SERVICE BULLETIN

MITSUBISHI MOTORS

PURPOSE : CHANGE	ISSUE NO. : MSB-14EXML15_17-001	DATE : 2014-10-02
SUBJECT : Omission of N mark for non-reusable parts and the tightening torque in the exhaust related parts.		<DESTINATION/MODEL> <M/Y> (For all destinations) As per attached sheet 1
GROUP : Gr:15(Intake exhaust)/Gr:17(Emission control)

<4B11-TURBO>

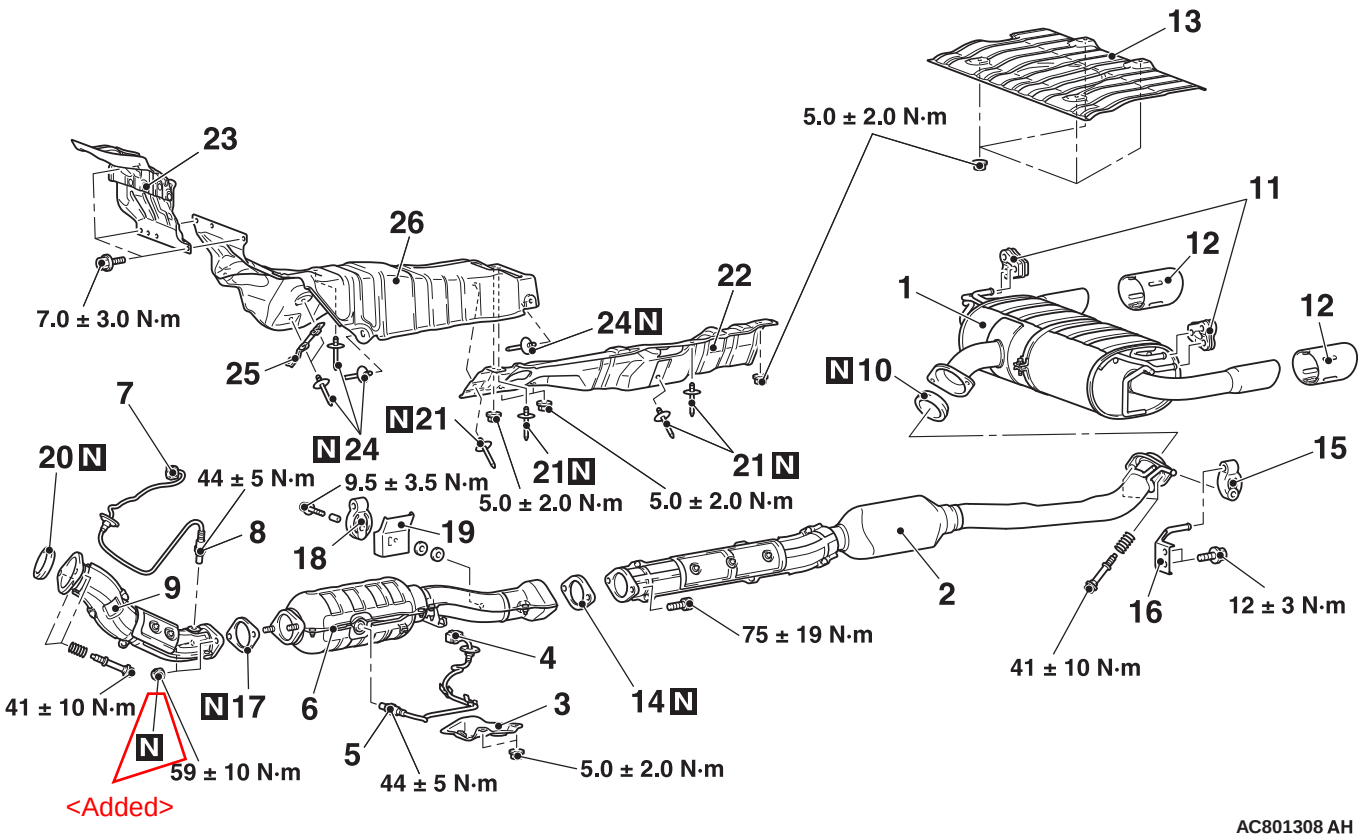
13
5.0 ± 2.0 N·m
23
11
26
12
22
1
12
7.0 ± 3.0 N·m
24 N
25
N 10
7
N 21
N 24
20 N
44 ± 5 N·m
9.5 ± 3.5 N·m
21 N
21 N
15
5.0 ± 2.0 N·m
5.0 ± 2.0 N·m
8
19
18
9
2
16
12 ± 3 N·m
75 ± 19 N·m
4
41 ± 10 N·m
41 ± 10 N·m
N 17
6
3
14 N
N
5
59 ± 10 N·m
44 ± 5 N·m
5.0 ± 2.0 N·m
<Added>
AC801308 AH

<4N1>

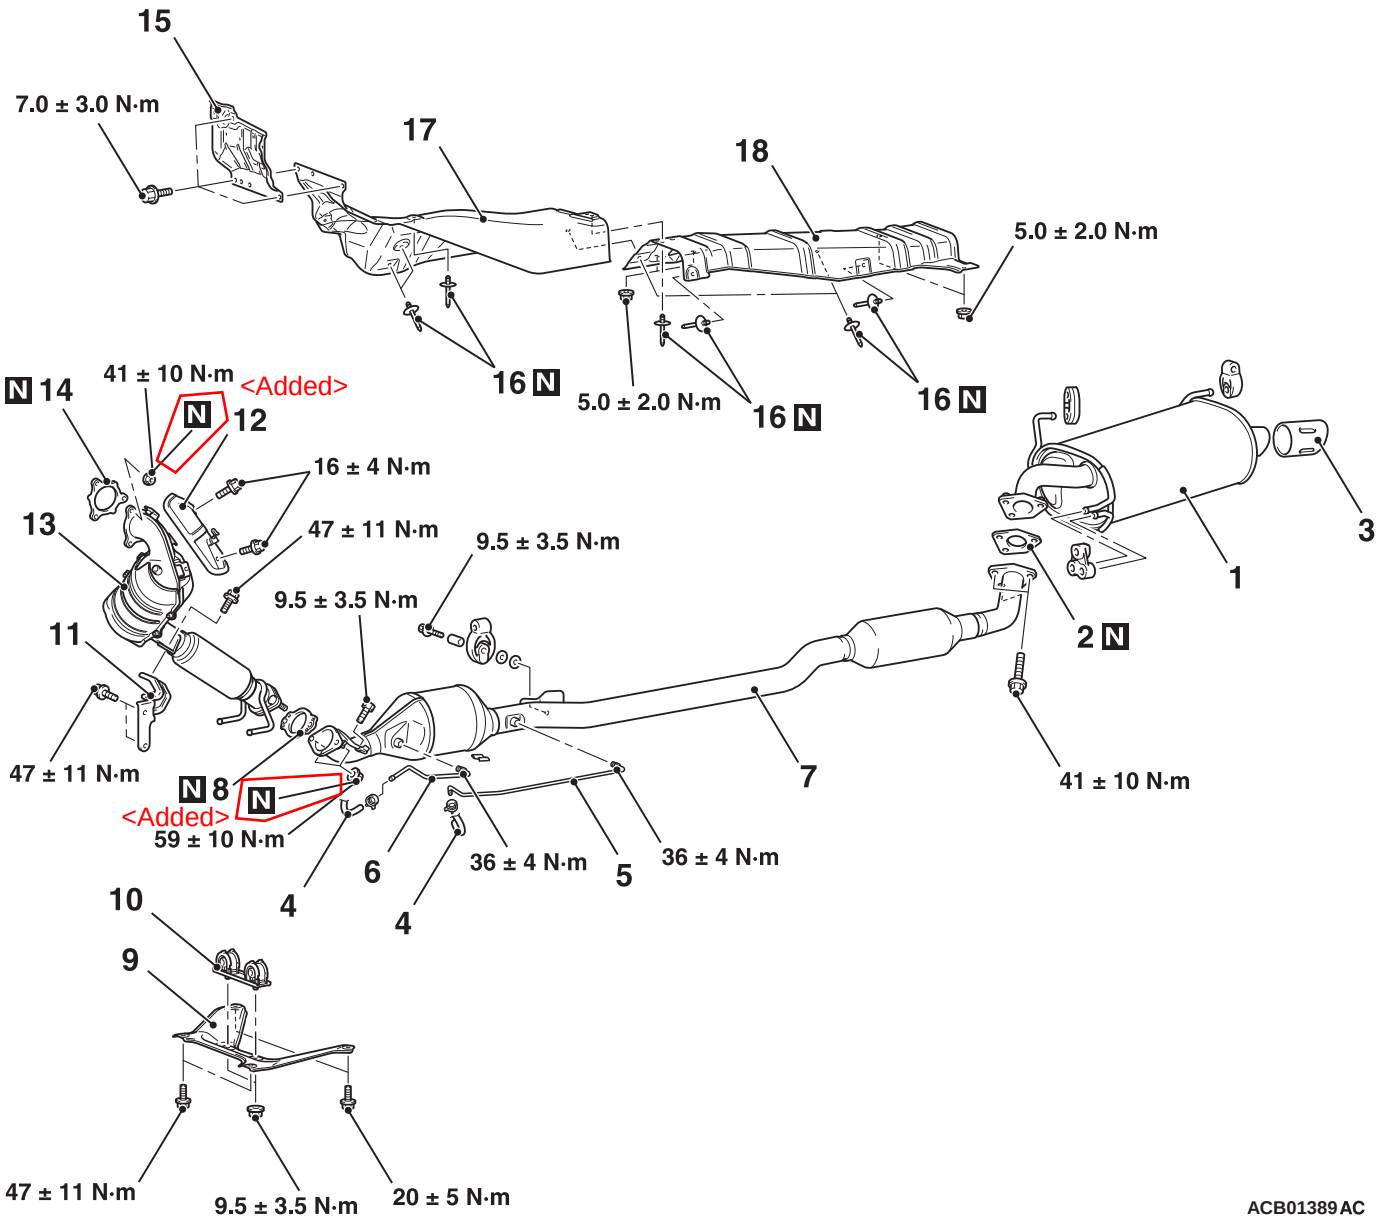
15
7.0 ± 3.0 N·m
17
18
5.0 ± 2.0 N·m
16 N
5.0 ± 2.0 N·m
16 N
16 N
N 14
41 ± 10 N·m
<Added>
N 12
16 ± 4 N·m
13
47 ± 11 N·m
9.5 ± 3.5 N·m
9.5 ± 3.5 N·m
11
47 ± 11 N·m
N 8
N
<Added>
59 ± 10 N·m
4
6
4
36 ± 4 N·m
5
36 ± 4 N·m
7
1
3
2 N
41 ± 10 N·m
10
9
47 ± 11 N·m
9.5 ± 3.5 N·m
20 ± 5 N·m
ACB01389AC

<4B1 (2WD)>

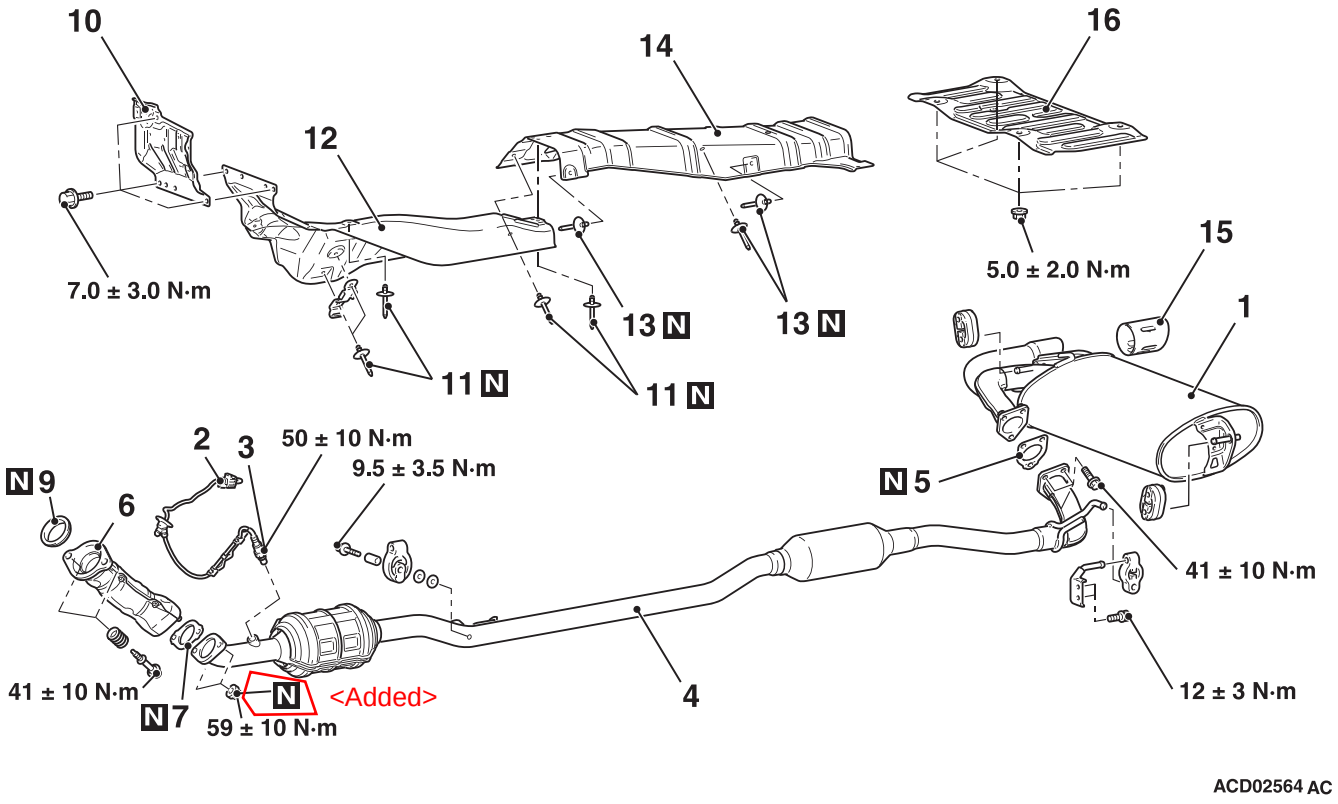
10
14
16
12
7.0 ± 3.0 N·m
5.0 ± 2.0 N·m
15
1
13 N
13 N
11 N
11 N
2
3
50 ± 10 N·m
9.5 ± 3.5 N·m
N 9
6
N 5
41 ± 10 N·m
41 ± 10 N·m
N 7
59 ± 10 N·m
N
<Added>
4
12 ± 3 N·m
ACD02564 AC

<4B1 (4WD)>

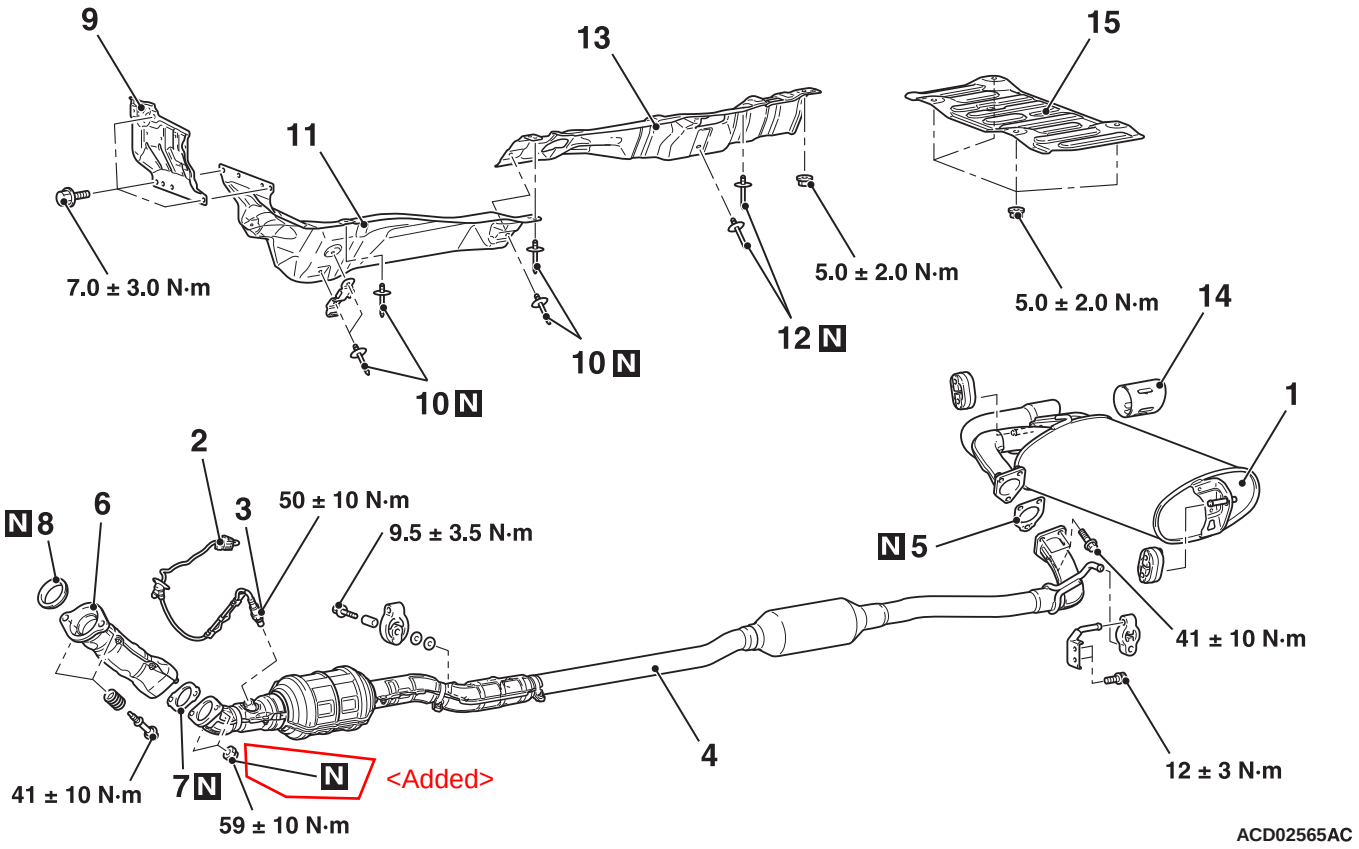
9
13
15
11
7.0 ± 3.0 N·m
5.0 ± 2.0 N·m
5.0 ± 2.0 N·m
14
1
12 N
10 N
10 N
2
N 8
6
3
50 ± 10 N·m
9.5 ± 3.5 N·m
N 5
41 ± 10 N·m
4
41 ± 10 N·m
7 N
N
<Added>
59 ± 10 N·m
12 ± 3 N·m
ACD02565AC

<6B3>

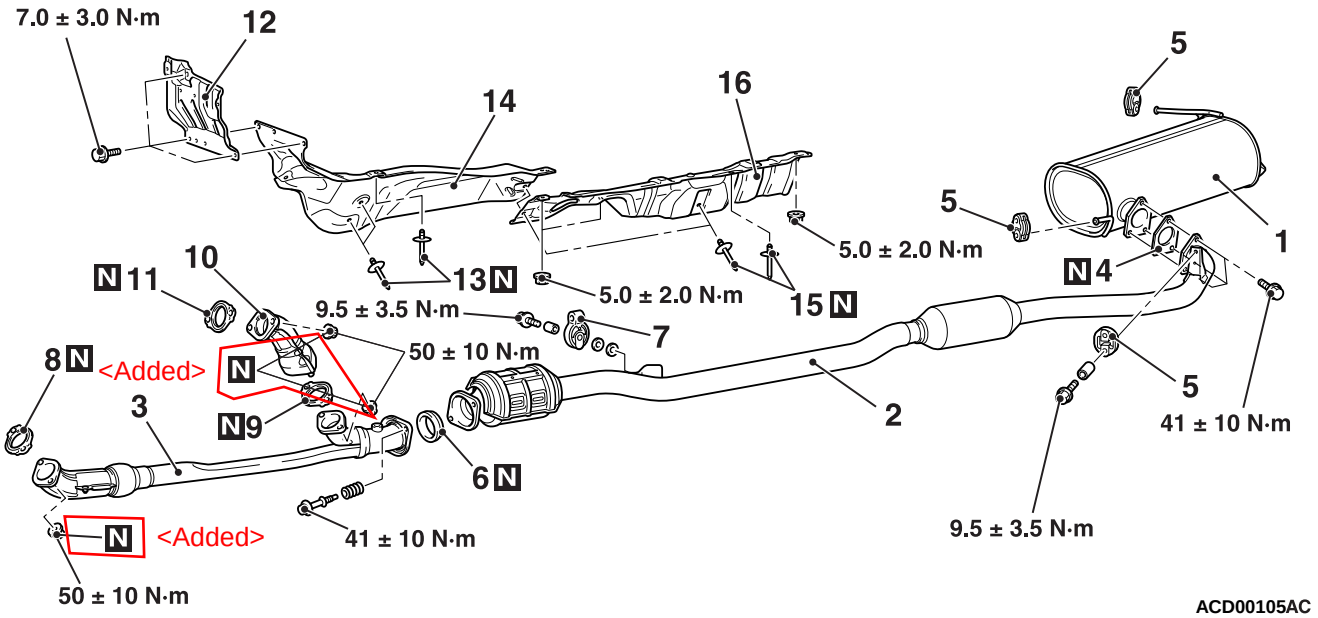
7.0 ± 3.0 N·m
12
14
16
5
5
1
5.0 ± 2.0 N·m
N 11
10
13 N
5.0 ± 2.0 N·m
15 N
N 4
9.5 ± 3.5 N·m
7
50 ± 10 N·m
8 N
<Added>
N
3
N 9
2
5
41 ± 10 N·m
6 N
N
<Added>
41 ± 10 N·m
9.5 ± 3.5 N·m
50 ± 10 N·m
ACD00105AC

<4G6>

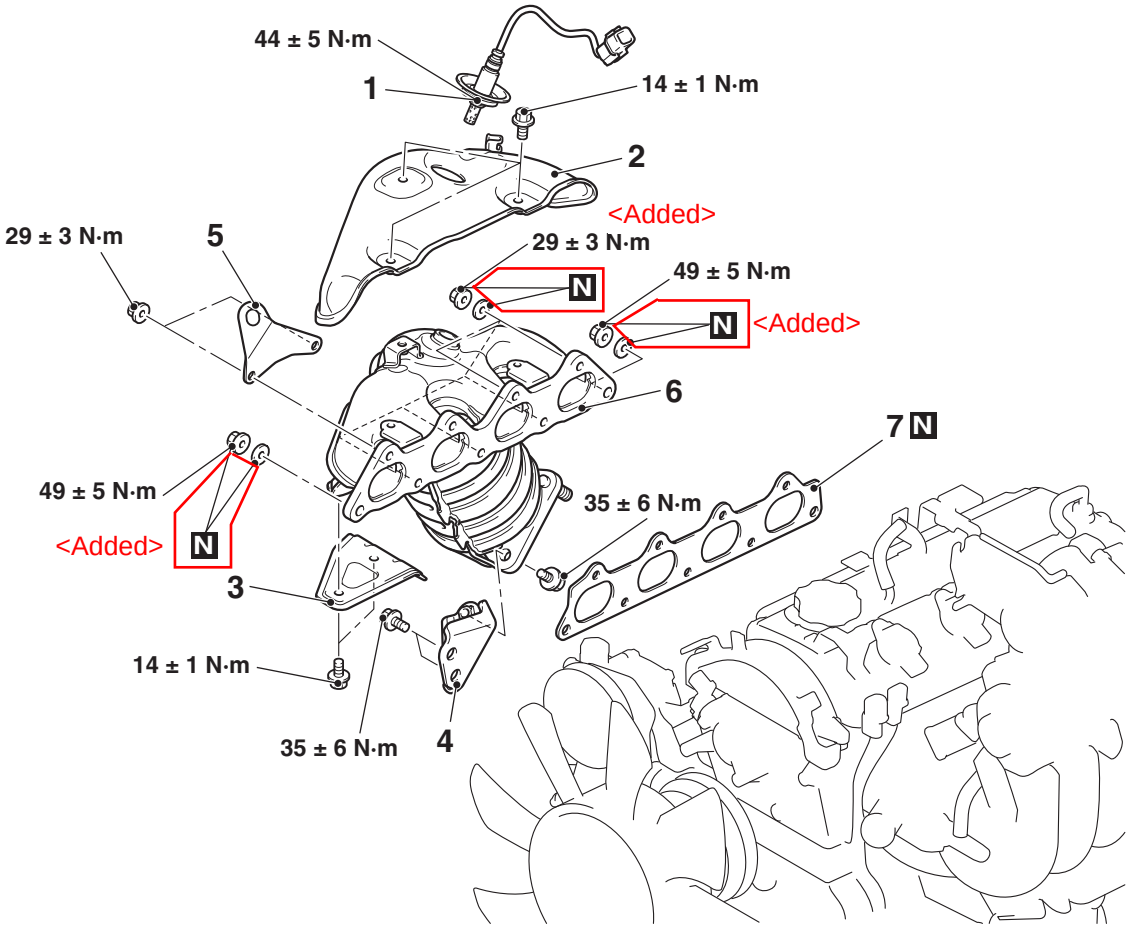
44 ± 5 N·m
1
14 ± 1 N·m
2
<Added>
29 ± 3 N·m
5
29 ± 3 N·m
N
49 ± 5 N·m
N
<Added>
6
7 N
49 ± 5 N·m
<Added>
N
35 ± 6 N·m
3
14 ± 1 N·m
35 ± 6 N·m
4

<4G6>

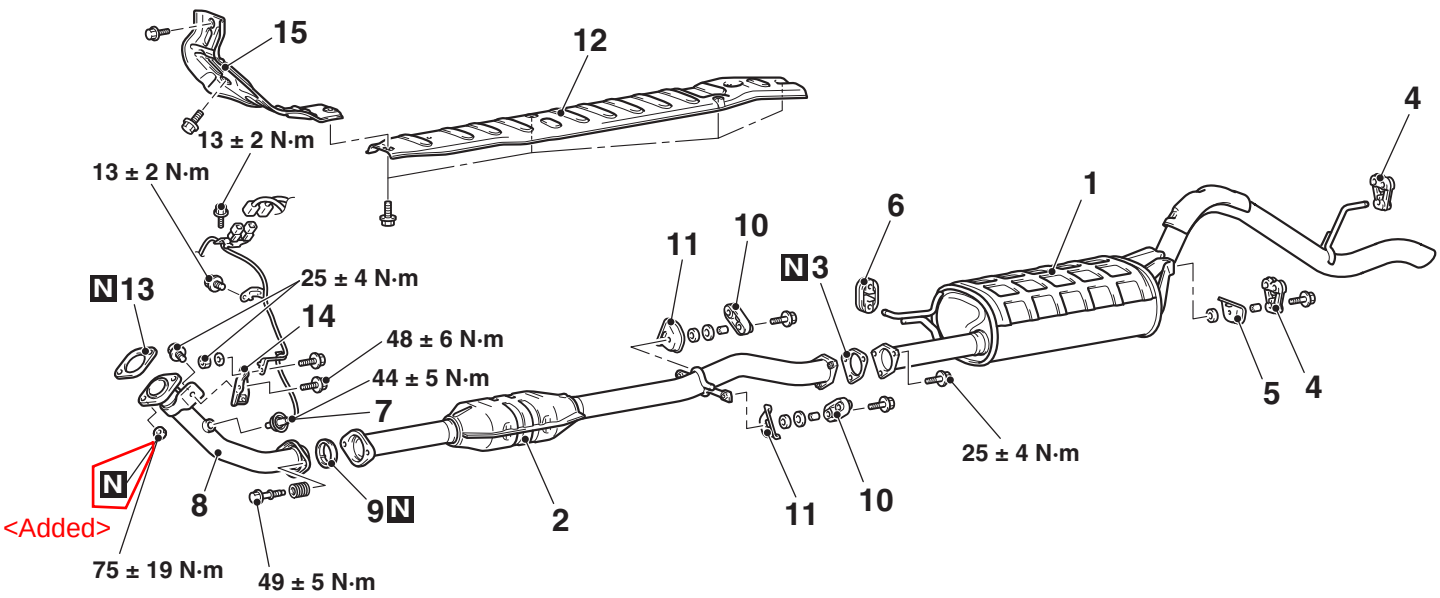
15
12
13 ± 2 N·m
13 ± 2 N·m
4
1
6
11
10
N 3
N 13
25 ± 4 N·m
14
48 ± 6 N·m
44 ± 5 N·m
7
5
4
25 ± 4 N·m
N
8
9 N
2
11
10
<Added>
75 ± 19 N·m
49 ± 5 N·m

<6G7>

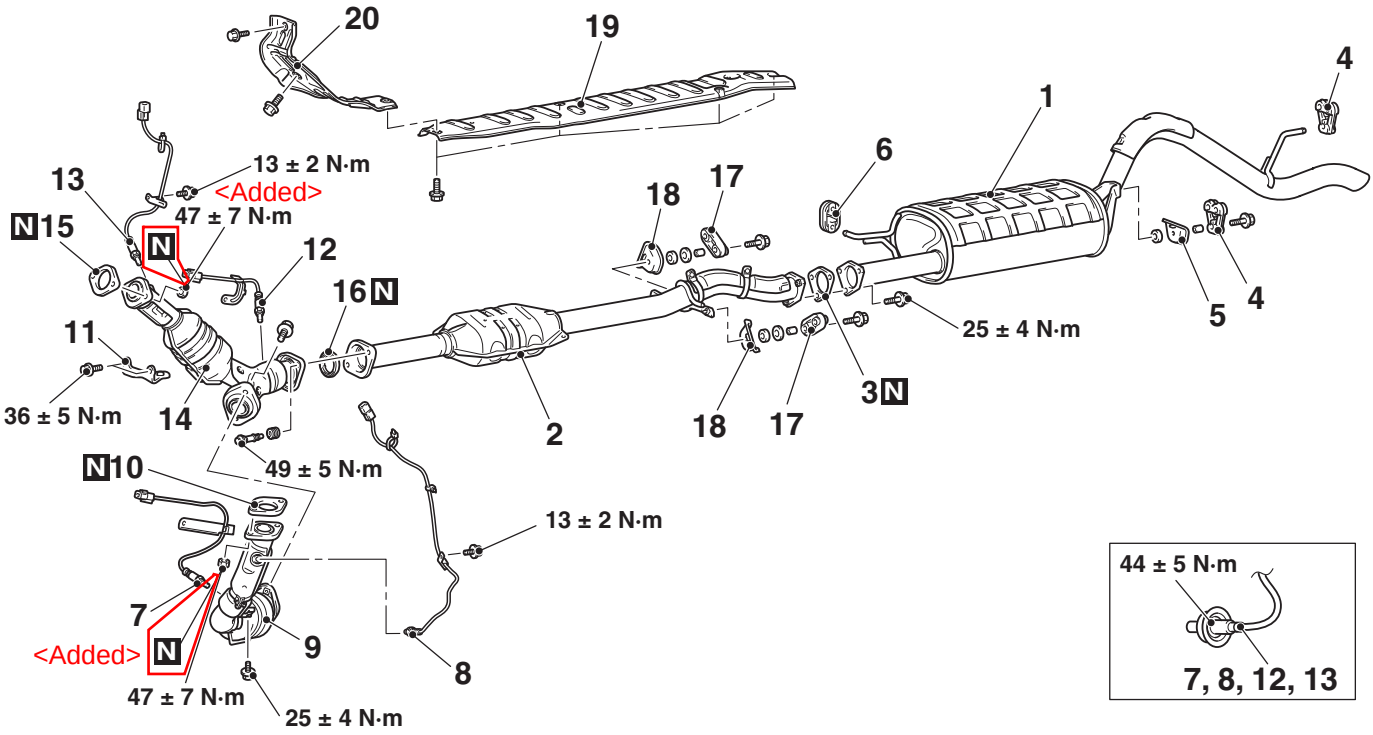
20
19
4
1
13 ± 2 N·m
<Added>
47 ± 7 N·m
13
N 15
N
12
16 N
18
17
6
11
36 ± 5 N·m
14
49 ± 5 N·m
2
18
17
25 ± 4 N·m
3 N
5
4
N 10
13 ± 2 N·m
7
<Added>
N
9
8
47 ± 7 N·m
25 ± 4 N·m
44 ± 5 N·m
7, 8, 12, 13

Attached sheet 13 (8/10)

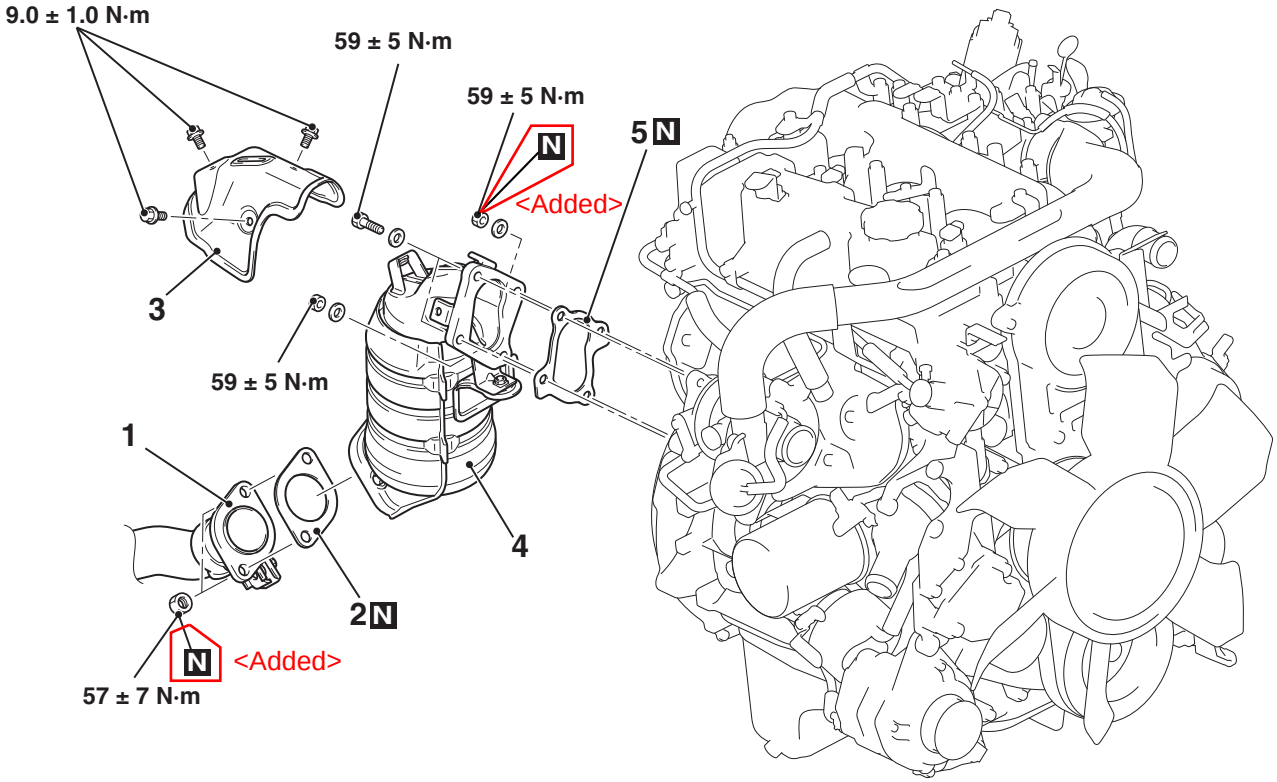
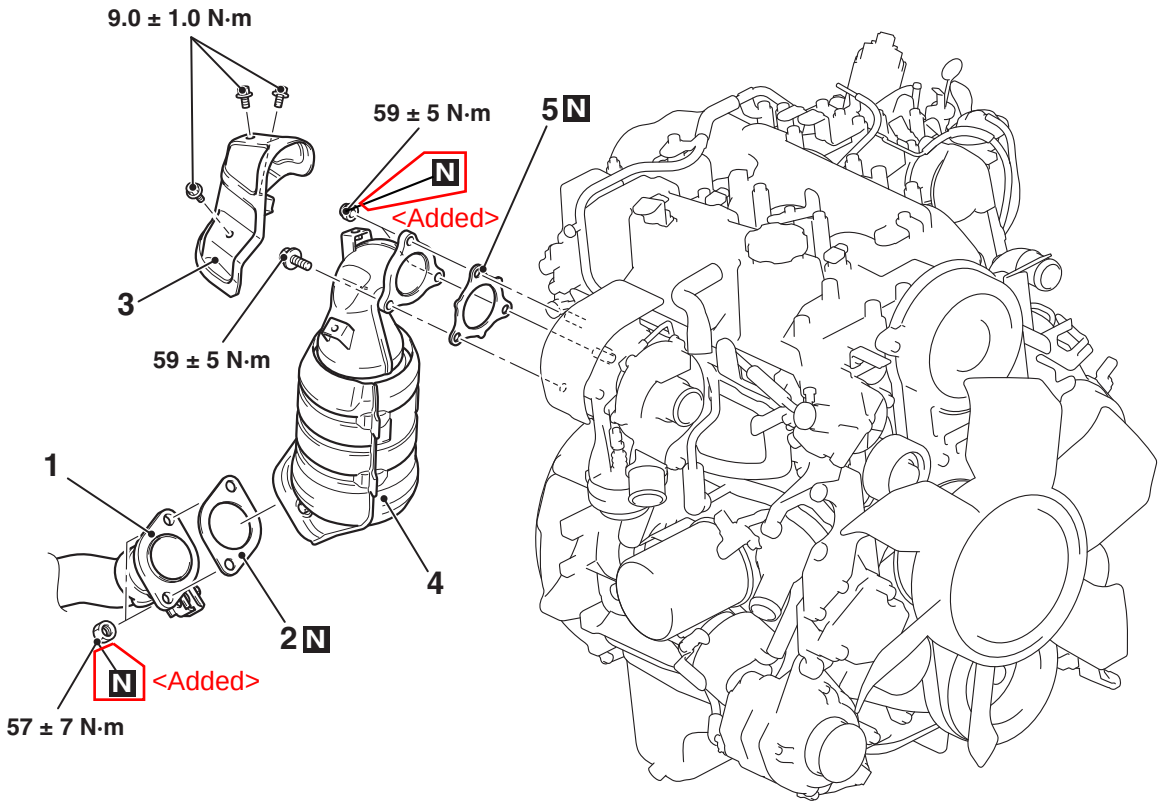
9.0 ± 1.0 N·m
59 ± 5 N·m
59 ± 5 N·m
N
<Added>
5 N
3
59 ± 5 N·m
1
4
2 N
N
<Added>
57 ± 7 N·m

9.0 ± 1.0 N·m
59 ± 5 N·m
N
<Added>
5 N
3
59 ± 5 N·m
1
4
2 N
N
<Added>
57 ± 7 N·m
